REMEDIATION SYSTEM EVALUATION

ELISKIM FACILITY
ANDERSON COUNTY, SOUTH CAROLINA

Report of the Remediation System Evaluation,
Site Visit Conducted at the Eliskim Facility, Anderson County, South Carolina
April 29, 2003

EPA 542-F-04-024
June 2004
www.epa.gov/tio
clu-in.org/optimization

FIGURE 1-1. THE ELISKIM PROPERTY, DOWNGRAIDENT AREA, AND MONITORING WELL LOCATIONS INDICATING TCE CONCENTRATIONS FROM THE 2002 SAMPLING EVENT.

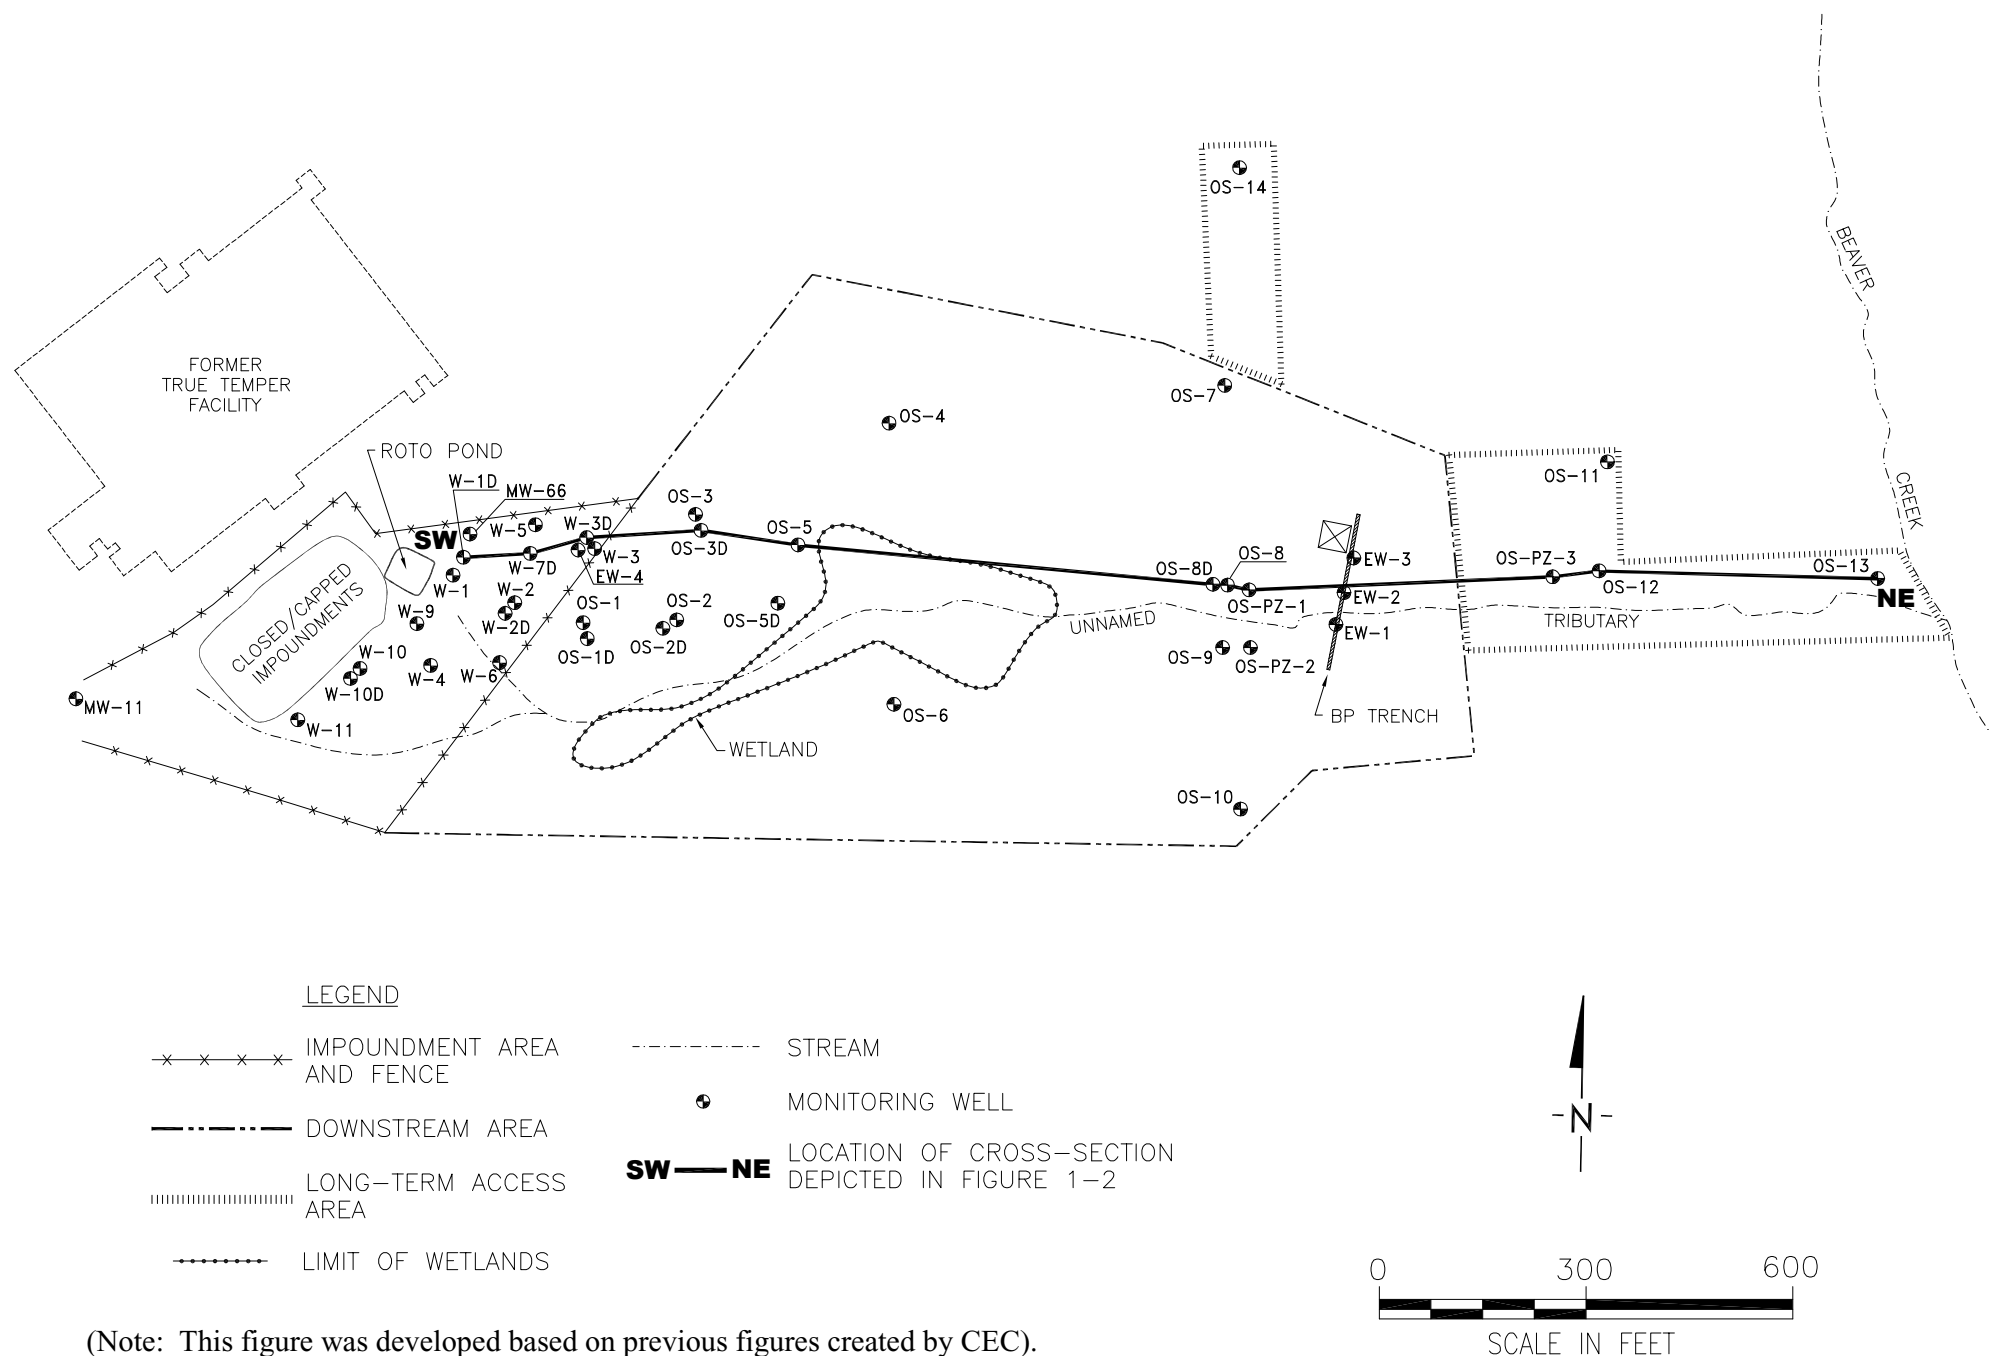
The Eliskim site is a closed hazardous waste management facility located approximately one mile south of Anderson, South Carolina. Key land parcels are illustrated on Figure 1-1. The original facility (the “Impoundment Area”) consisted of approximately five acres of property with ponds and lagoons used for hazardous waste management associated with a plant originally owned by True Temper that was located on an adjoining parcel. The plant was sold to Emhart Corporation in 1985, and is currently operating as a truck depot. An additional 20 acres east of the Impoundment Area (the “Downstream Area”) was purchased as part of the ground water remediation. A ground water collection trench and a treatment plant are located on this 20-acre parcel. The property north, east, and south of the Downstream Area is owned by Mr. Joseph Nehme (the “Nehme Property”), and that property contains several monitoring wells that are monitored and are accessible under access agreements.

As illustrated on Figure 1-1, two drainage ditches channel runoff from the former True Temper plant property and the capped area to form the unnamed tributary to Beaver Creek. Beaver Creek is located approximately 2,000 feet northeast of the original 5-acre facility.

The depth of VOC contamination has not been defined below OS-5D and OS-8D. Vertical delineation may also be incomplete near W-7D.

This estimated width is approximately the width of the property at the location of the BP trench. This width may or may not be enough to capture all contamination. Although OS-10 had undetectable VOC concentrations in 2002, OS-7 had a TCE concentration of 240 ug/L in 2002. OS-7 is located at the edge of the property boundary approximately 500 feet upgradient of the trench where the property is wider than 500 feet. However, the greater uncertainties associated with this type of calculation are with the transmissivity estimate and the assumptions made about the aquifer thickness.

- Ground water contamination should be delineated vertically in three areas of the plume. If substantial contamination is found at depth, additional characterization efforts may be required to better understand ground water flow and contaminant transport at these greater depths and to determine if capture offered by the BP trench is sufficient.

FIGURE 1-2. SOUTHWEST/NORTHEAST CROSS SECTION DEPICTED ON FIGURE 1-1.

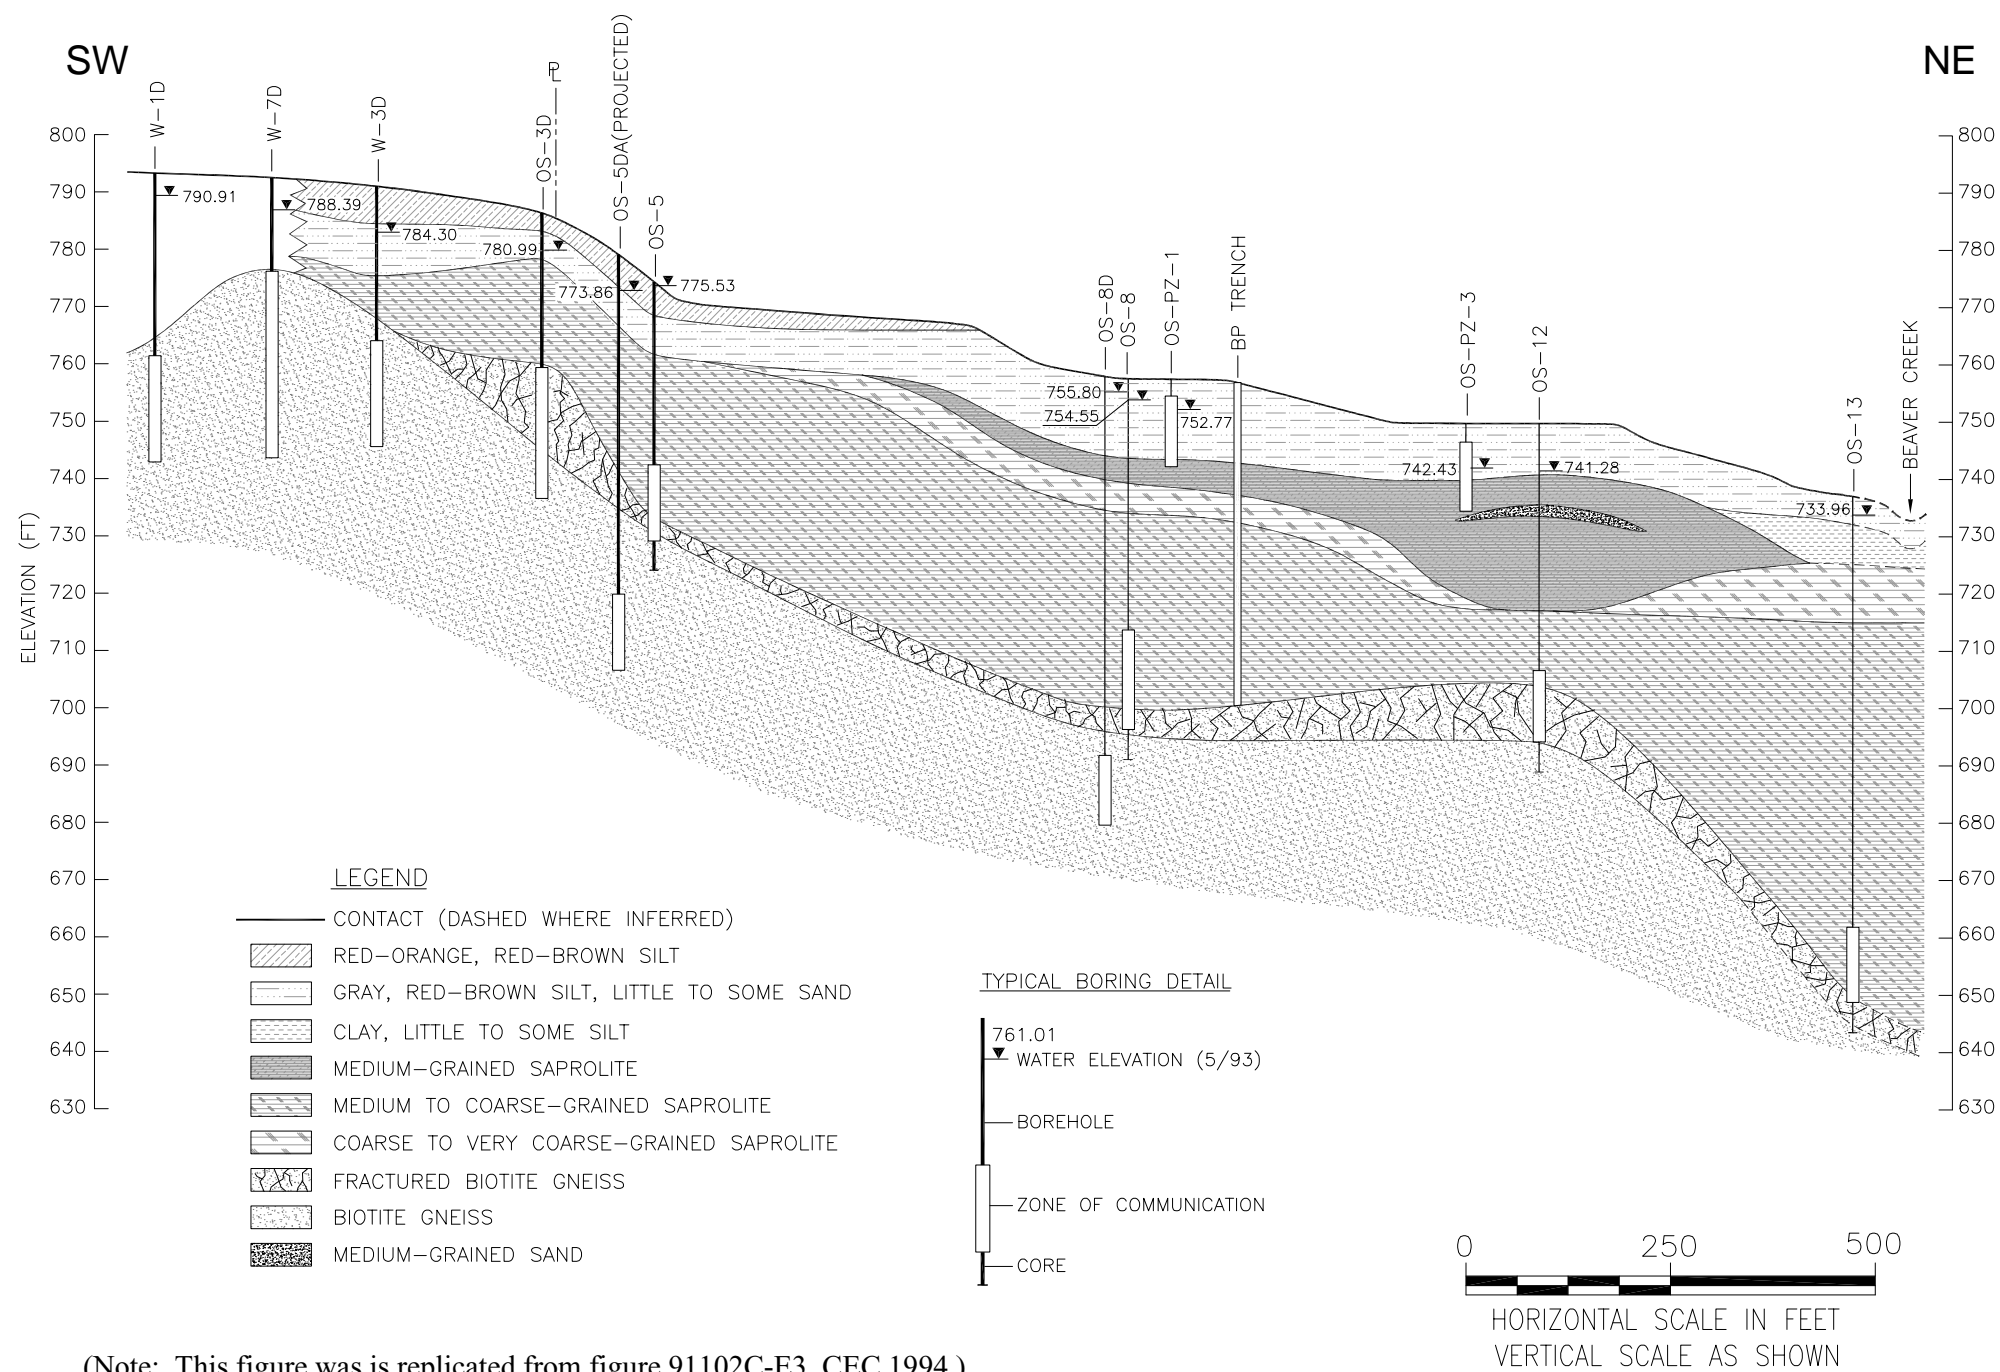
The site is located in the Piedmont physiographic province. Bedrock beneath the site is a biotite gneiss which is overlain by overburden (saprolite which grades from weathered bedrock to silty clay and clayey silt). The contact between competent bedrock and overburden is not well defined. Competent bedrock has been observed onsite at depths ranging from 10 to 51 feet, and at depths up to 88 feet beneath areas along the unnamed tributary. A geologic cross-section is shown in Figure 1-2, and the location of that cross-section is indicated on Figure 1-1.
